Wollongong Local Planning Panel Assessment Report | 13 July 2021

WLPP No.	Item No.2
DA No.	DA-2021/383
Proposal	Residential - demolition of existing dwelling and structures and construction of detached dual occupancy, two retaining walls and Subdivision - Torrens title - two (2) lots
Property	19 Russell Street, Balgownie
Applicant	Robert Gizzi – Design Workshop Australia
Responsible Team	Development Assessment and Certification - City Centre Team (CB)
Prior WLPP meeting	Nil

ASSESSMENT REPORT AND RECOMMENDATION

Figure 1: Detailed ground floor plan of dual occupancy at 19 Russell Street, Balgowrie

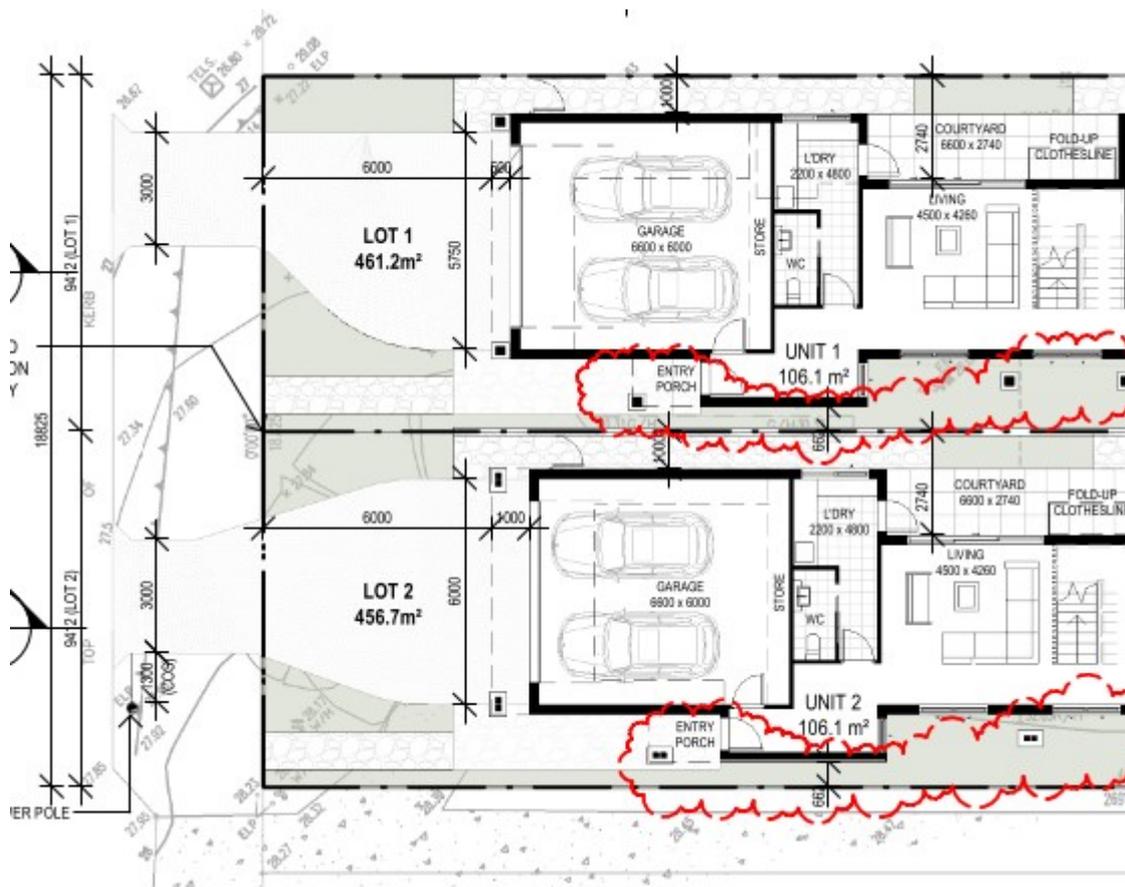
The south side setback for both dwellings is 662mm which is non-compliant with the minimum required setback of 900mm for walls [cl 4.3.2.1]. The length of the non-compliant section is about 4.4m long, it is confined to the ground floor and consists of a solid masonry wall about 2.7 metres high. Eaves and gutters comply with the minimum side setback requirement of 450mm. The extent of the variation is 238mm. This variation allows for a dedicated entryway where the front door and entry porch faces the street and the double garage provides effective parking for residents in accordance with Council requirements.

b) There are no windows on the non-compliant wall section. Privacy will be reinforced with a 1.8m high side boundary fence. Therefore, the design is considered to provide adequate privacy for neighbours.

PHOTO 1

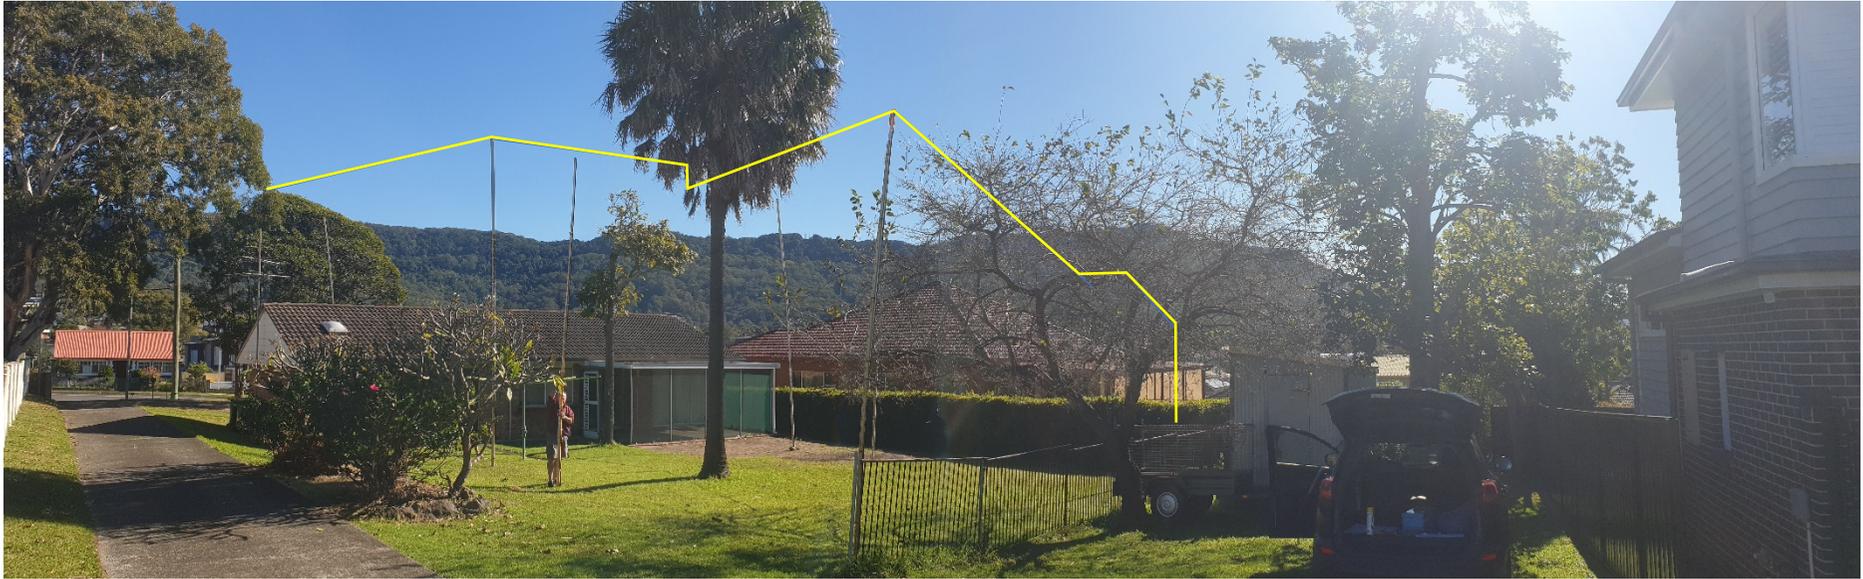
Comment:- As outlined in relation to items (a) and (b) above, the setback to the southern side boundary has no bearing on views – increasing the setback does not result in any reduction in view loss. The setbacks provided to the rear boundary are a minimum of 8.4m to the single storey component and about 16.4m to the two-storey component, which exceed the setbacks required by WDCP 2009 (being, 900mm and 8m, respectively). Providing greater setbacks than the required minimums, enables the maintenance of some of the view corridor from No.23 Russell Street (see Photos 1 and 2 attached).

Panoramic view from boundary with No.23 Russell Street, with roof line of proposed dual occupancy shown yellow.
